Addendum #1-

Date of Issuance: Monday, September 21, 2026
Project **Enhanced Endodontics – Panama City Beach, FL**

Responses below by John Bozarth or Antonio Reeves, unless noted otherwise.

A1.2

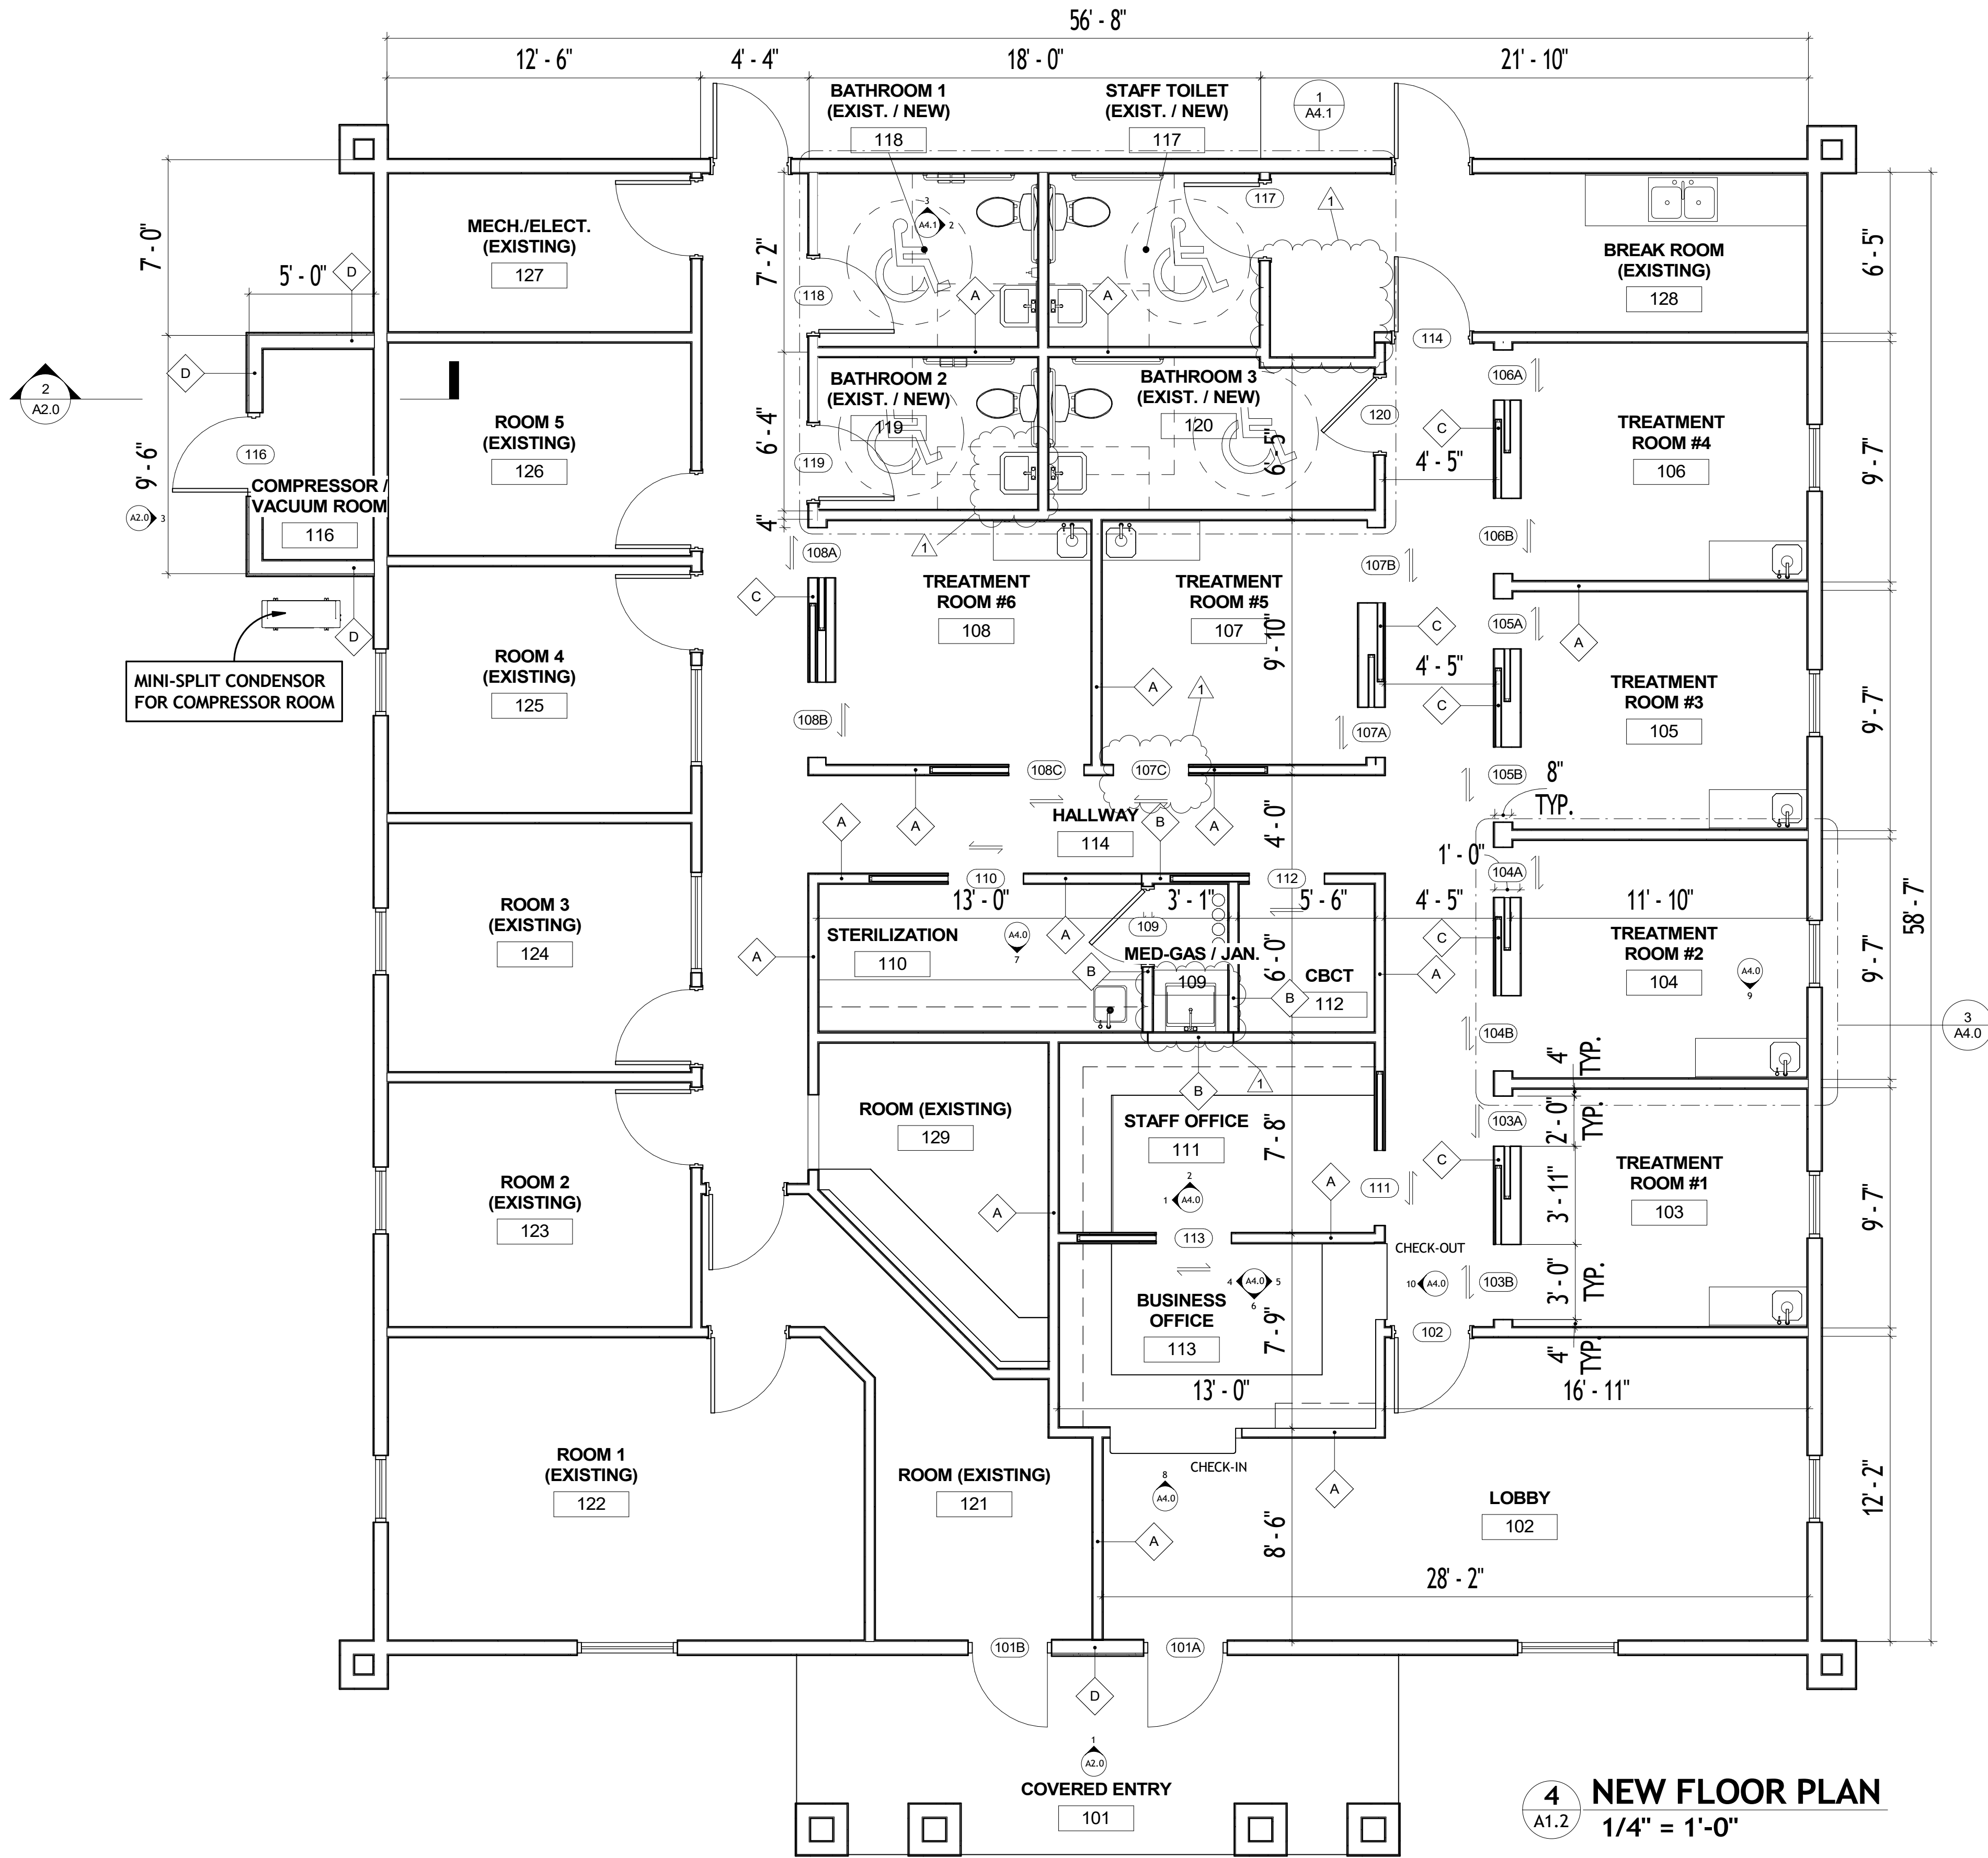
2. Sheet A1.2 – NEW FLOOR PLAN
 - d. Relocated mop sink. See also plumbing plan.
 - e. Removed Vanity and add ADA lav.
 - f. Added a pocket door at Treatment Room #5.

- g. All framing to be metal studs. See wall types.
3. Sheet A1.4 – NEW REFLECTED CEILING PLAN
 - h. Removed ceiling at original Janitor's closet location.

A4.1

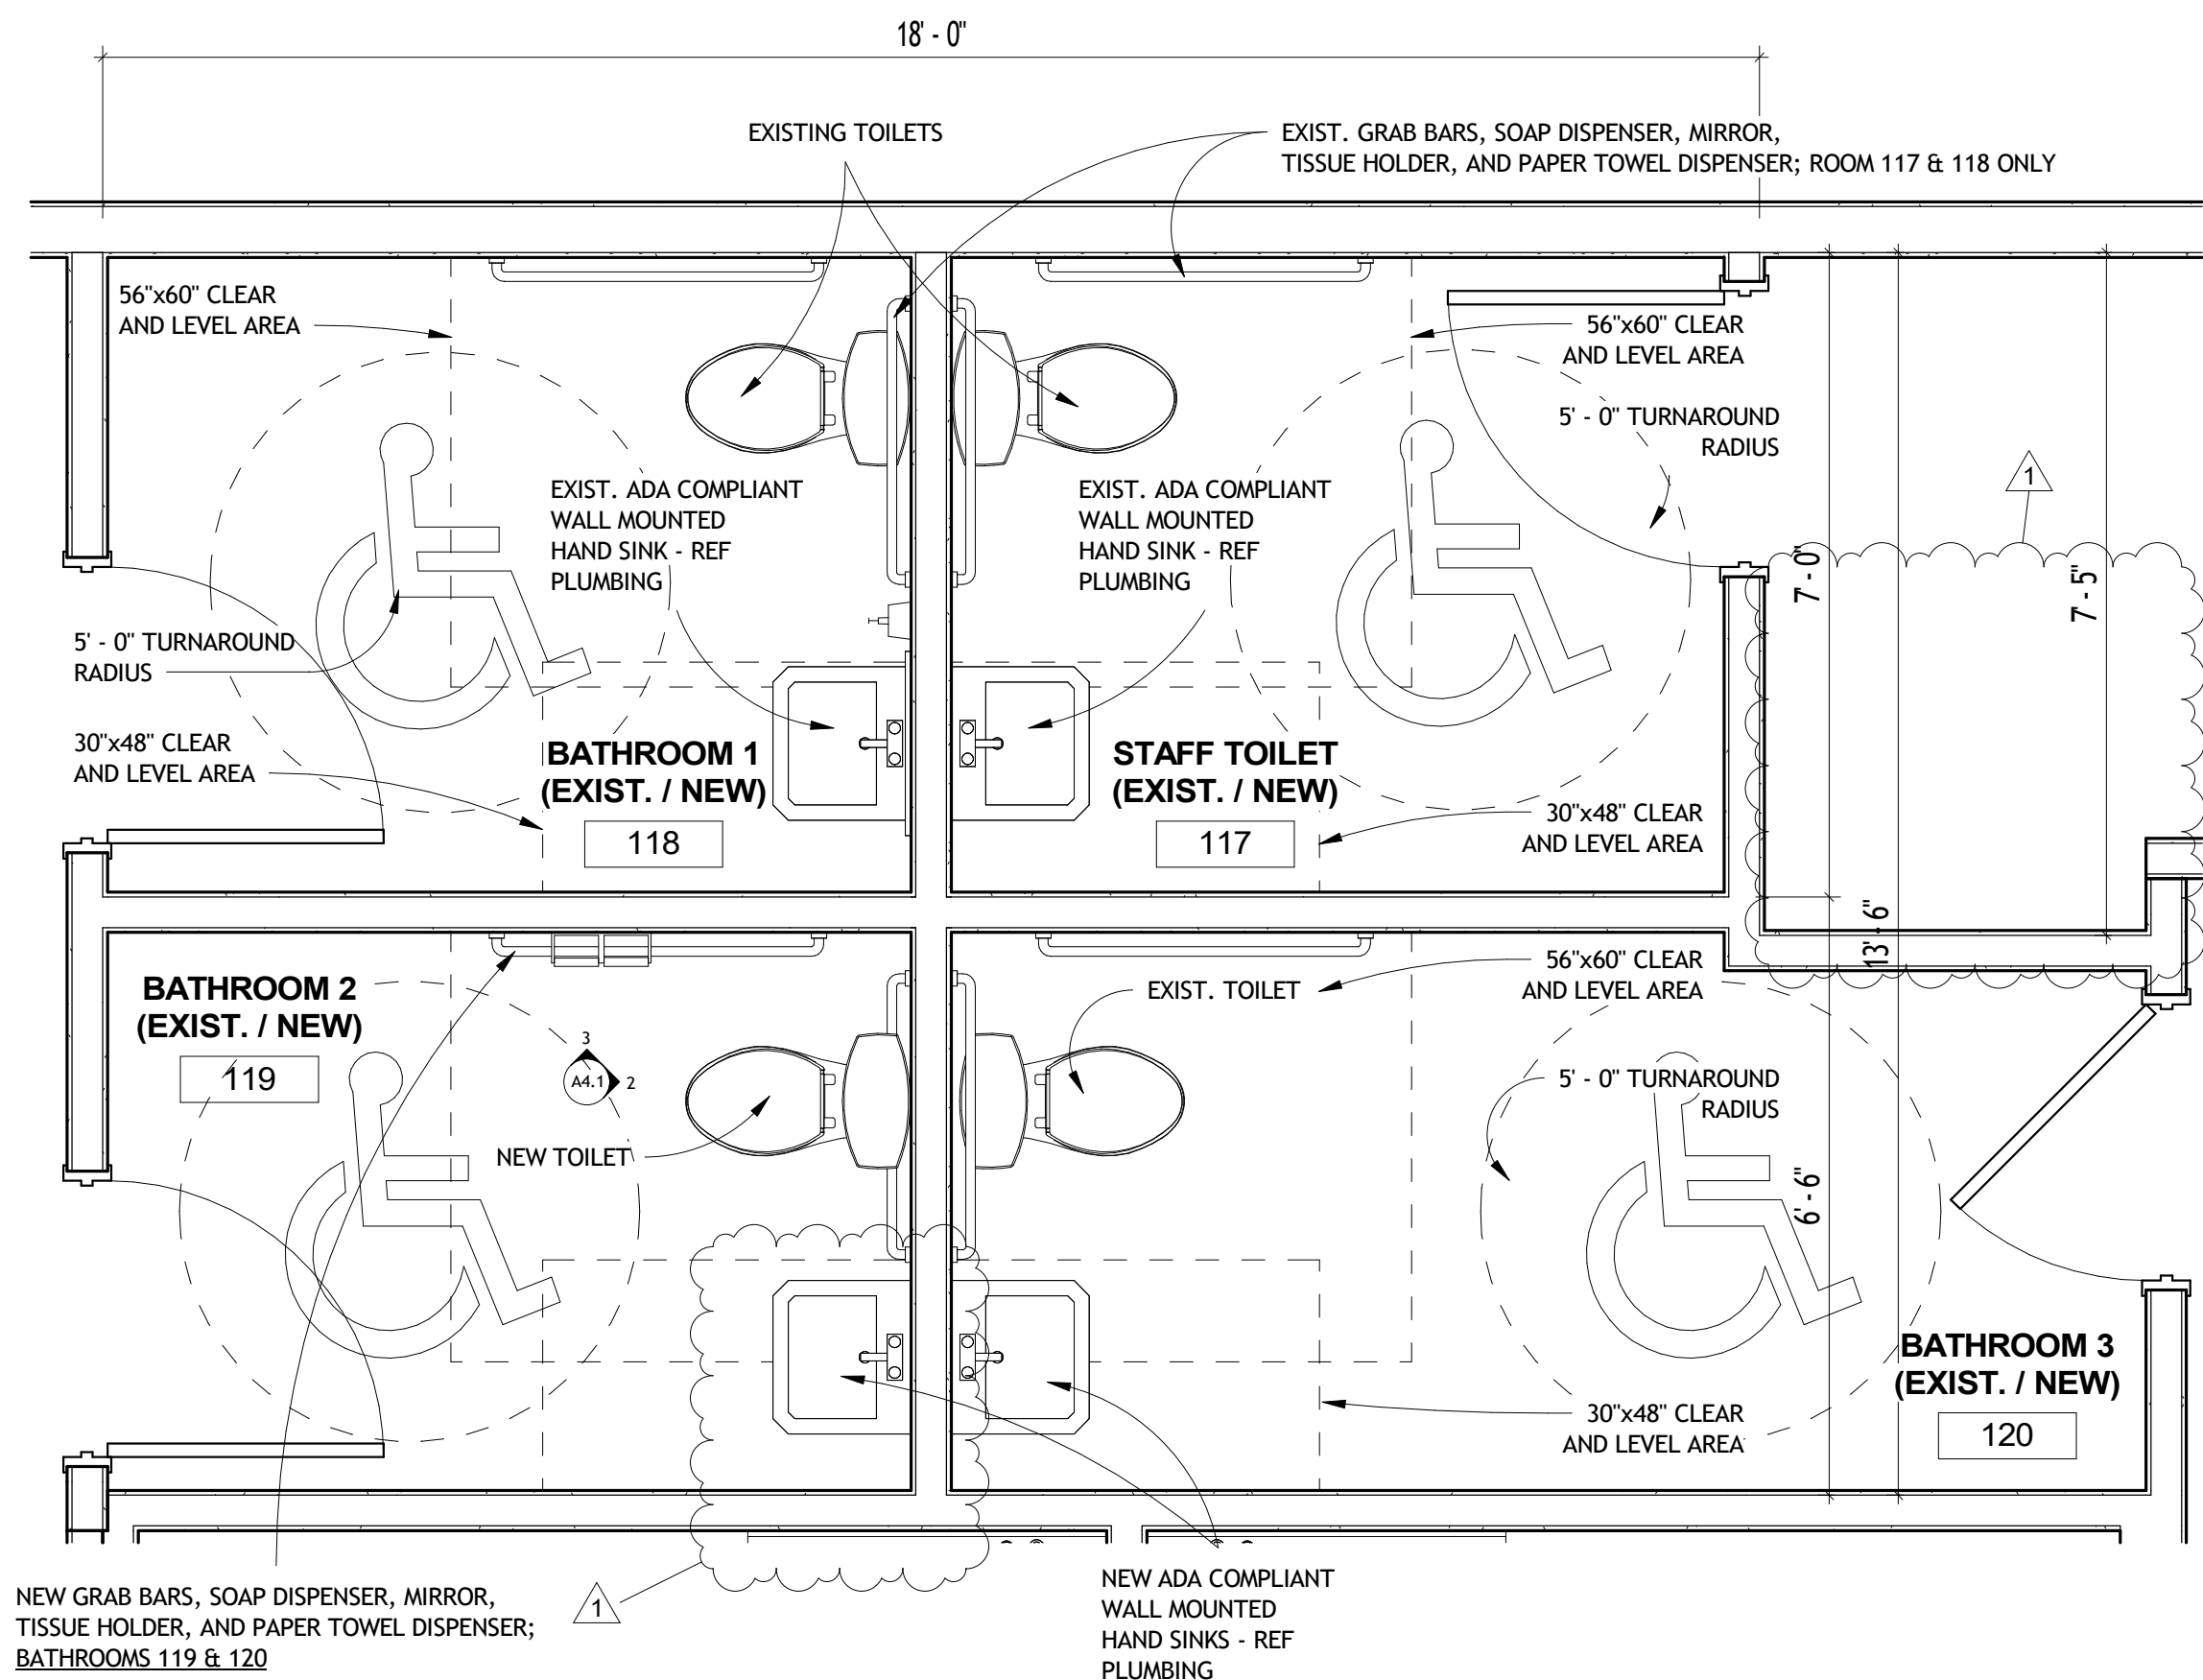
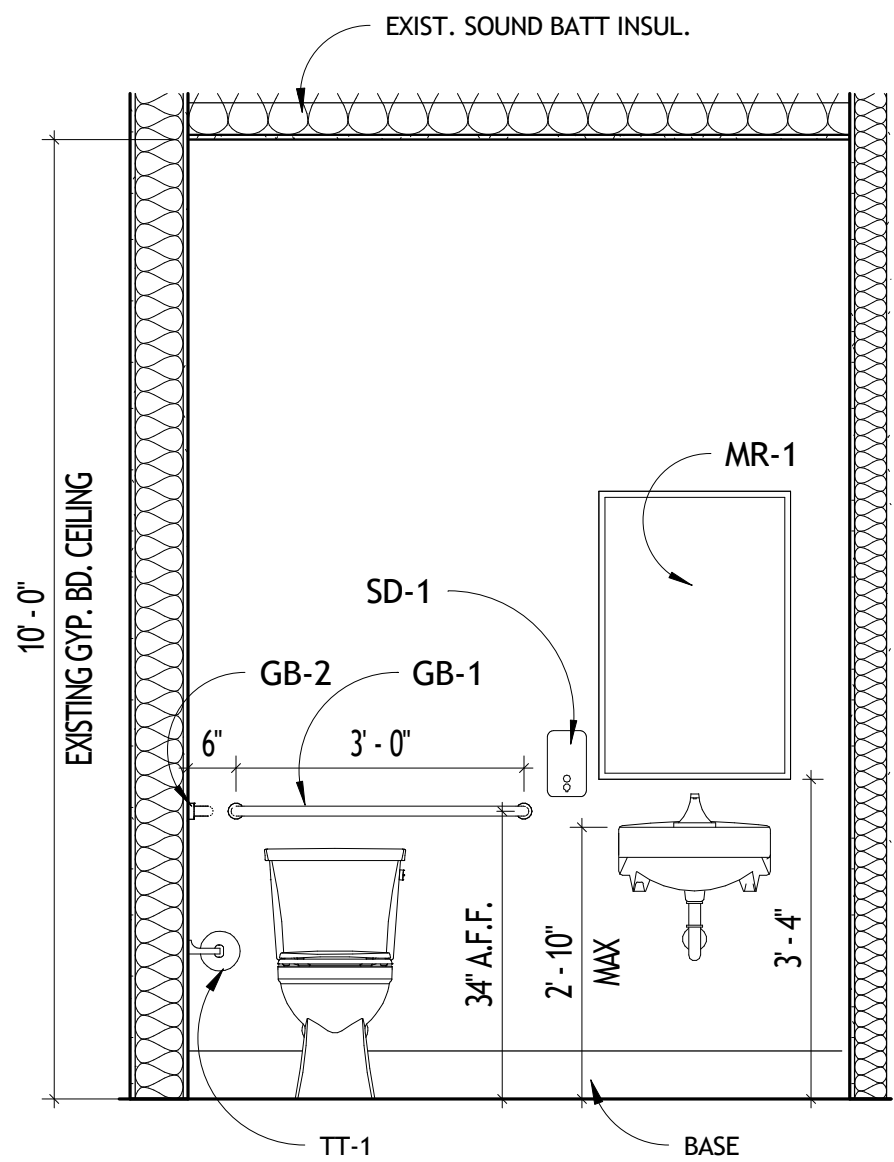
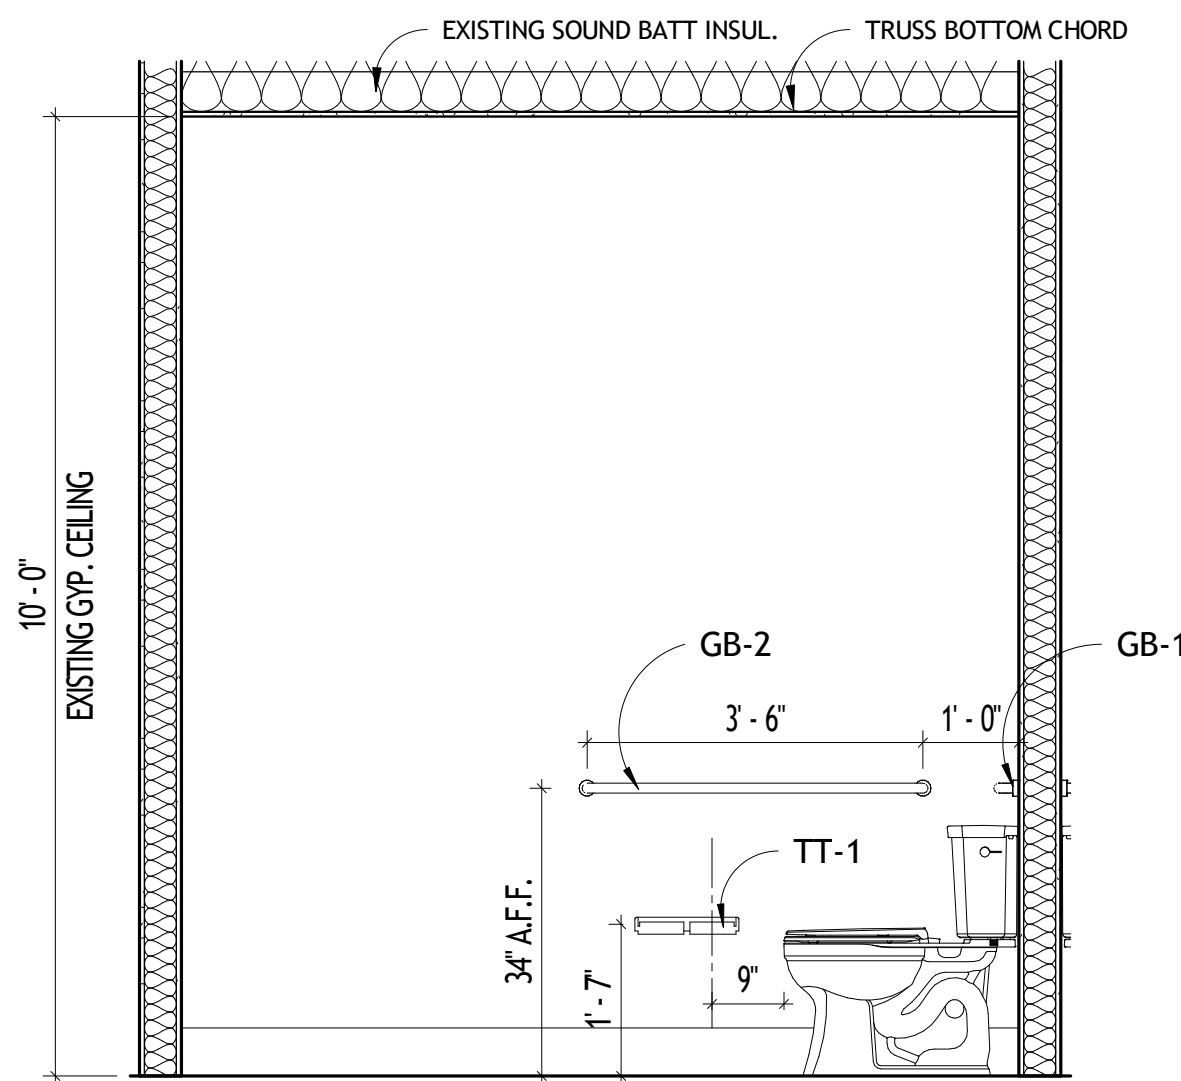
4. Sheet A4.0 – ENLARGED PLAN & INTERIOR ELEVATIONS
 - i. Added Treatment Room cabinet depth.
5. Sheet A4.1 – ENLARGED PLAN & INTERIOR ELEVATIONS
 - j. Removed ceiling at original Janitor's closet location.

- k. Removed Vanity and add ADA lav.
 - l. Revised Toilet Accessories layout and count.
6. Sheet A5.0 – ROOM FINISH SCHEDULE
 - m. Bath walls to be painted. See schedule and notes.
